# UNITED STATES PATENT AND TRADEMARK OFFICE

APPLICATION NO.	FILING DATE	FIRST NAMED INVENTOR	ATTORNEY DOCKET NO.	CONFIRMATION NO.
10/797,968	03/11/2004	Darin L. Moore	IMG.028	4995
26984	7590	09/14/2005		
WILLIAM L. LONDON 3010 LEE AVENUE P.O. BOX 152 SANFORD, NC 27330			EXAMINER FETZNER, TIFFANY A	
			ART UNIT	PAPER NUMBER
			2859

<b>Office Action Summary</b>	Application No. 10/797,968	Applicant(s) MOORE ET AL.	
	Examiner Tiffany A. Fetzner	Art Unit 2859

**FIG. 1**  
(PRIOR ART)

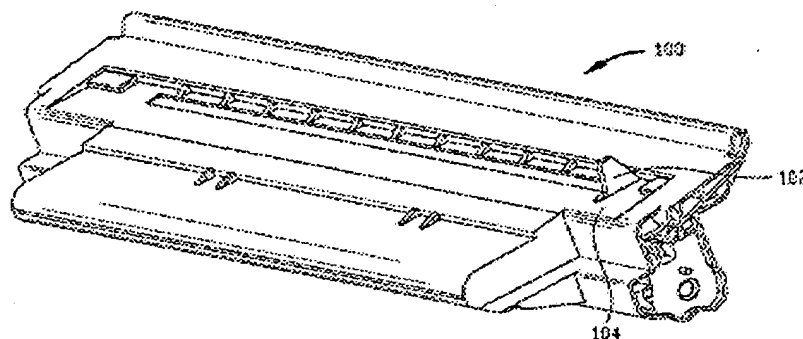
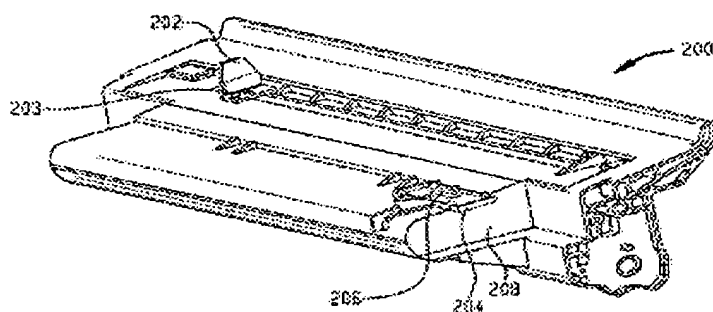
9. With respect to **Claim 1**, **Rogers et al.**, teaches "A method of modifying a toner cartridge intended for operation in a first type of imaging device to operate in a second type of imaging device" [See abstract, page 1 paragraphs [0006], and [0007]], "the method comprising: providing the toner cartridge adapted for operation in the first type of imaging device, said toner cartridge comprising a drum shutter" (i.e. shutter fin 102 and the shutter main body which encloses and surrounds waste bin 104) "connected to a waste bin" (i.e. waste bin 104) [See page 1 paragraph [0017]], **Rogers et al.**, lacks directly teaching but does suggest from figures 1 and 2 that "said drum shutter" (i.e. the examiner is broadly interpreting the shutter fin component 102, of figure 1; or the modified shutter fin component 202, of figure 2; in combination with the unlabeled shutter main body which encloses waste in 104 as the "drum shutter" of the **Rogers et**

al., toner cartridge 100,200 in figures 1 and 2.) "comprising first and second shutter

arms" (i.e. See the unlabeled right and left enclosing arm-like structures of the unlabeled shutter main body from prior art figure 1 of **Rogers et al.**, which are located to the right and left of waste bin 104). The examiner notes that shutter fin 102, and/or the modified shutter fin 202 is / are interpreted as an aspect of the shutter main body of figures 1 and 2. The examiner notes that components 102, or 202 are located adjacent to the unlabeled, but illustrated, right / left shutter arm; which is also adjacent to waste bin 104. [See **Rogers et al.**, figure 1 and figure 2]. The examiner also notes that in figure 1 shutter fin 102 is a type of vertical shutter arm located on the right side of the shuttle main body, and that **Rogers et al.**, specifically teaches removing the fin like

shutter arm portion shown in figure 1, 'with a side cutter or the like' so that the toner cartridge can be installed in a different HP model printer. [See **Rogers et al.**, paragraph [0019]. Therefore It would have been obvious to one of ordinary skill in the art at the time that the invention was made that the **Rogers et al.**, reference, which teaches the limitation of 'removing the shuttle fin also intrinsically removes at least "a portion of a first shutter arm"', by this step (i.e. when prior art figure 1 is considered), even though the **Rogers et al.**, reference lacks identifying the illustrated shuttle arms on the right and left sides, of the prior art and modified shuttle fins of figures 1 and 2 with component numbers. [See **Rogers et al.**, pages 1-2 paragraph [0019], Figures 1 and 2; and the differences between **Rogers et al.**, figures 1 and 2.]

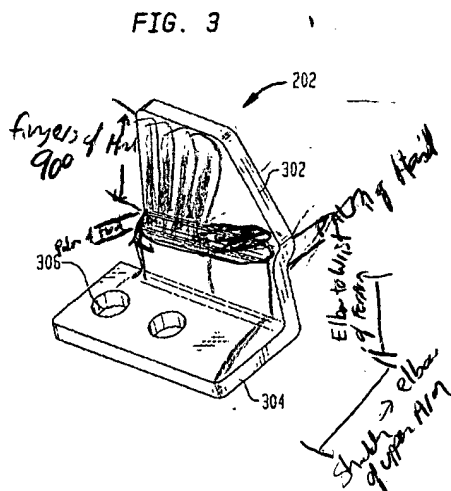
10. Additionally, **Rogers et al.**, teaches replacing the shuttle fin arm-like structure of figure 1 with a new modified shutter fin structure located in a new location on the shuttle main body of the toner cartridge of **Rogers et al.**, [See figures 2 and 3; pages 1-2 paragraphs [0019] and [0020]]. Because the replacement shuttle fin component 202 (i.e. shown clearly in figure 3) is not planar, and the vertical portion zigzags from an initial position to another position, depending on the reference point of one of ordinary skill in the art, there is intrinsically either a removed "upper portion" or a removed "lower portion" with respect to this component. Therefore it also would have been obvious to one of ordinary skill in the art at the time that the invention was made that figure 2, which shows unlabeled shuttle arms on the right and left sides of figure 2 as well as a replacement vertical arm-like shuttle (i.e. component 202), is also capable of satisfying applicant's limitation of a "first shutter arm" with a portion of the shutter arm removed.

Shape of figure 3 is Arm-Like because a Human Arm can form this basic shape

Shoulder to elbow = base 304 with Shoulder of upper Arm →  
 Elbow to Wrist of forearm is 90° with respect to upper Arm ↑ Horizontal  
 Palm of hand bent 90° at Wrist so Palm is up is part of the Offset →  
 Bend fingers 90° to the Palm Vertically Upwards = part 302 ↑
